SITE NOTICE

Consent No:	20172013	Date Printed: 25 September 2019
Applicant:	Spaghetti Junction Limited	
Site Address:	80 Byron Street Sydenham	
Legal Description:	Lot 1 DP 449853	
Work Type:	Addition to Factory - New Offices, Meeting and Store Room	
Email To:	todd@morelconstruction.co.nz

Inspection Type:	253 - Pre Cladding
Inspection Outcome:	Fail
Inspected By:	Steve Walders
Inspection Date:	25 September 2019

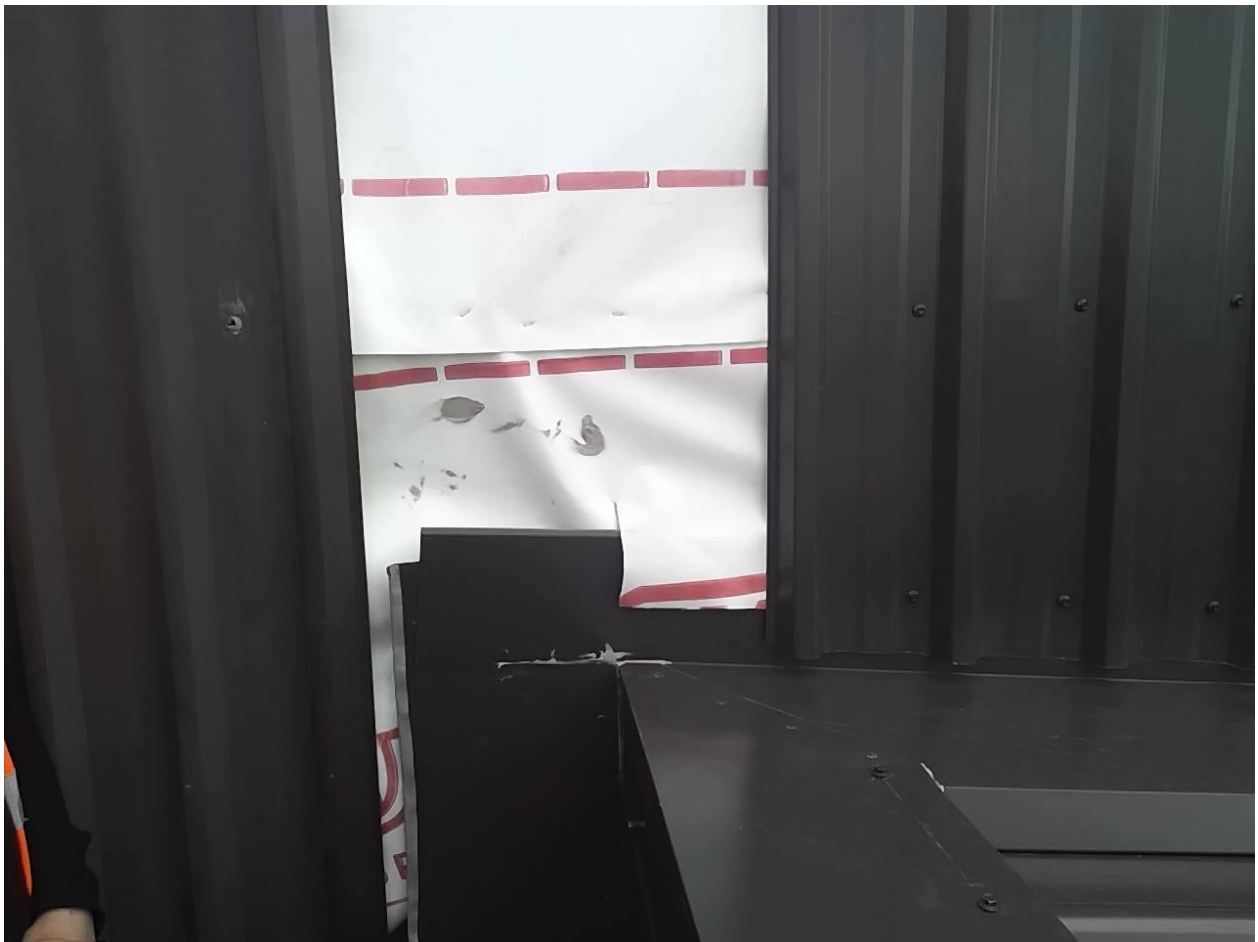
2. The consented plans show the bottom plate against
the floor slab. Now a nib wall lifting the bottom plate
off the slab as per detail shown on sheet A15 [see
attached photo].

1. Please provide updated drawings and details to
reflect the as built state.

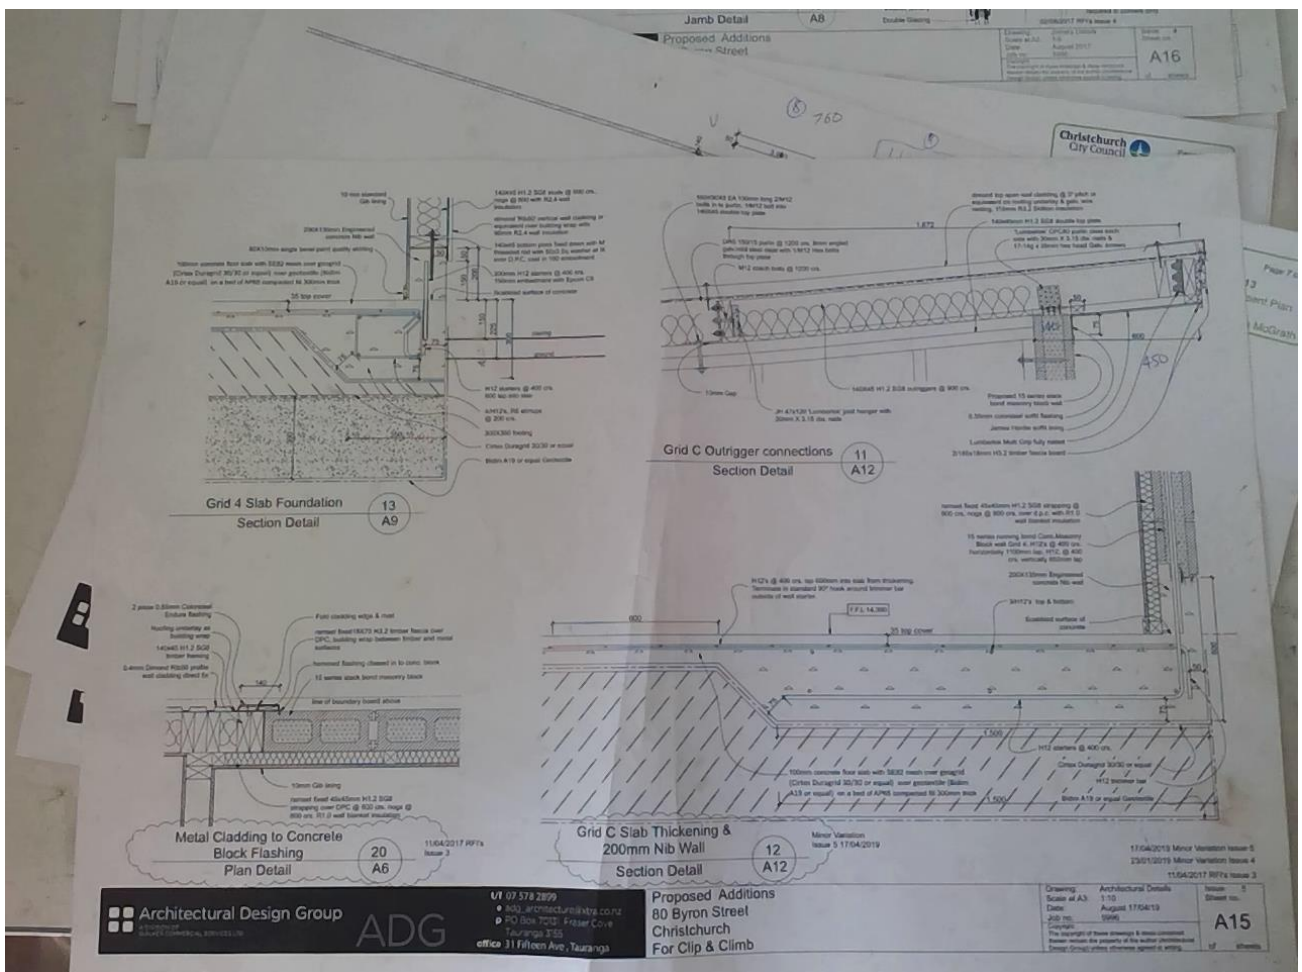
stephen.walders@ccc.govt.nz & to
codecompliance@ccc.govt.nz. Ensure that the email
has the project number and address within the
subject line.
3. Please have a another of building paper over the
leading edge of the apron flashing above the existing
large door opening as per site discussion.
